BIDDER'S SUBMITTAL

Company: Royal Construction Corp.

PROPOSAL, SPECIFICATIONS, BOND AND AFFIDAVIT FOR CONSTRUCTION OF THE TORRANCE TRANSIT PARK AND RIDE REGIONAL TERMINAL, FEAP 764 B2017-39

- 2) Reference part of Drawing Sheet EY600 (see next page).

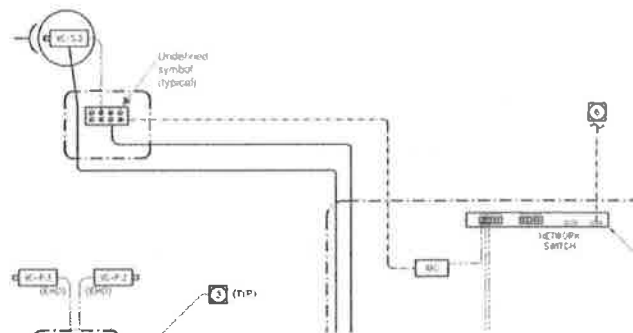
There is an undefined symbol on the single line drawing. Is this a hardened network switch? Is it to be provided by the City IT (like the other network hardware)?

A6b: The referenced device in the drawing attached to the Bidder's RFI (partial, marked up portion of plan shown above) is a hardened outdoor rated switch. It is specified in Section 282300, Article 2.2, Paragraph B.
